Inspection Report for North Sturbridge Road Solar Facility

NPDES ID No.: MAR10031G

Inspection Date: 08/24/2021

**FIGURE 1:
SWPPP
INSPECTION
SKETCH
8/26/2021**

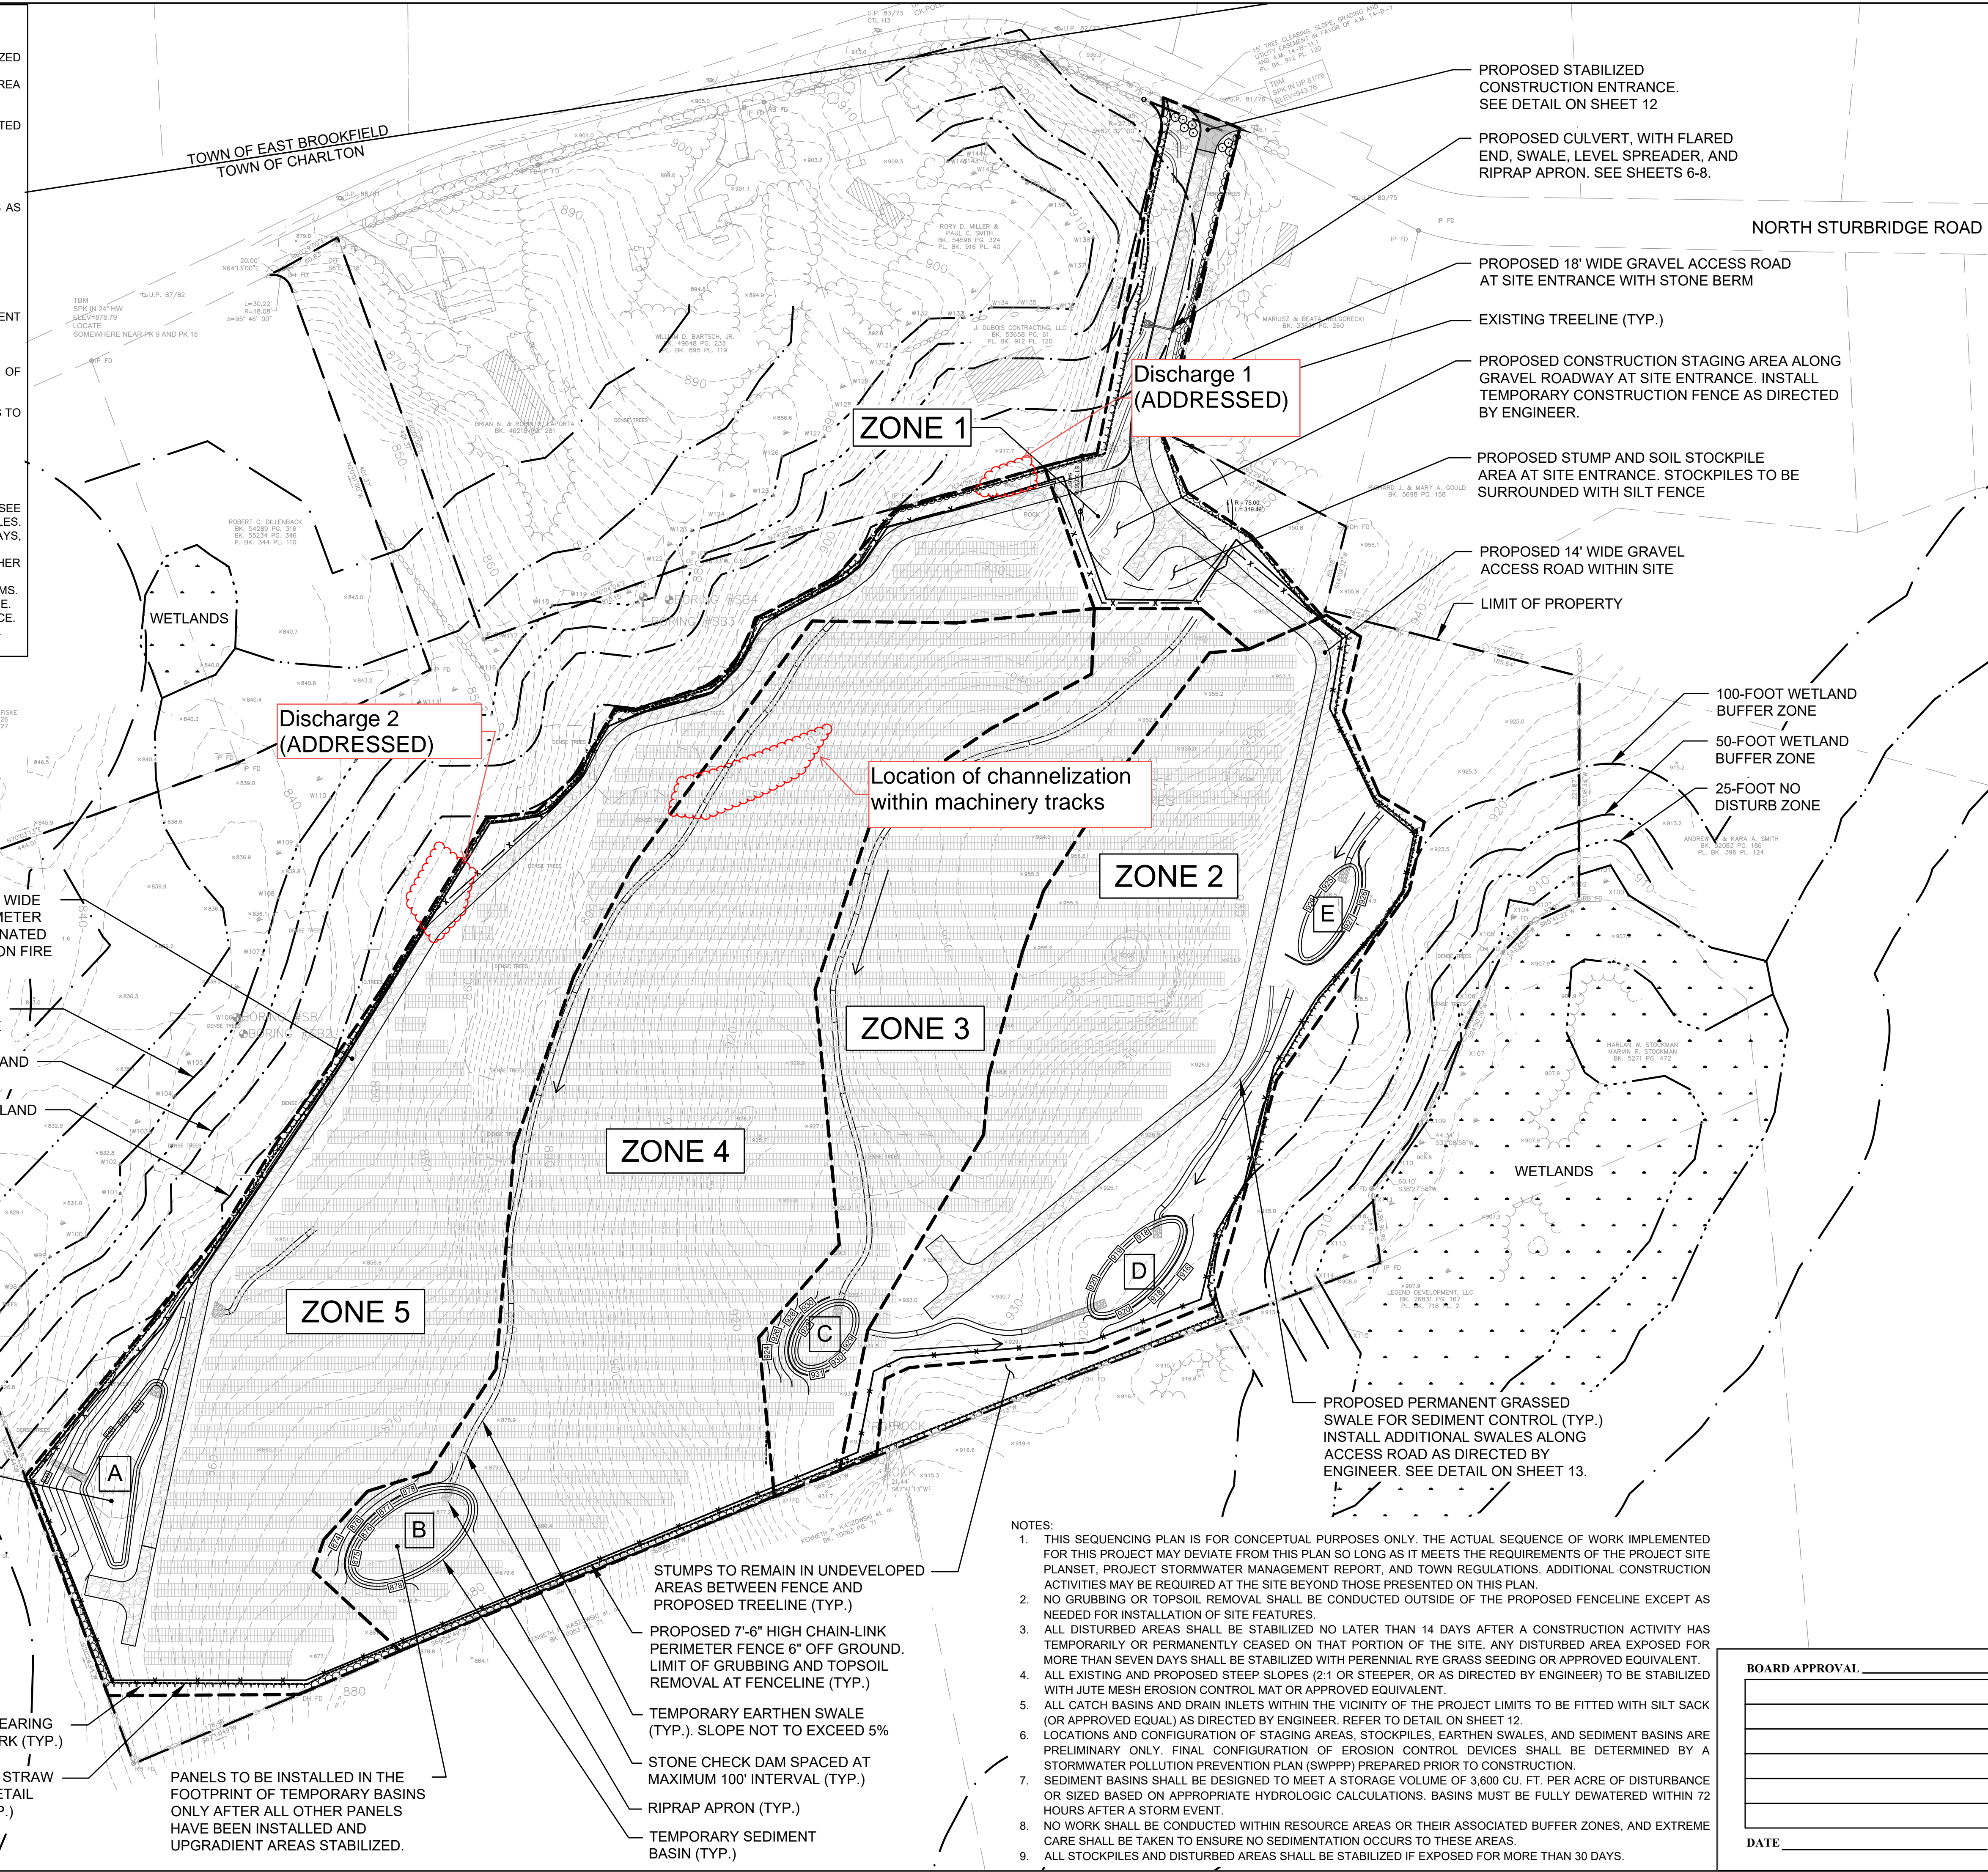
2. Informal access road along northern portion of the Site	Straw mulch or hydroseed	<input type="checkbox"/> Yes [Enter date] <input checked="" type="checkbox"/> No	Erosion channels are beginning to form within upgradient portions of the informal access road (Figure 1). The contractor indicated that stabilization by smoothing out soils and seeding or spreading mulch would occur on 7/30/2021. Stabilization of this area has not been initiated. After inspection of the area on 8/24/2021, it was determined that temporary swales would likely alleviate the issue of channelization in this area; however, these swales will not be constructed until work resumes at the Site in October (pending local approval). This area will continue to be monitored; however, stabilization is not required since the area is not discharging sediment beyond the limits of work.
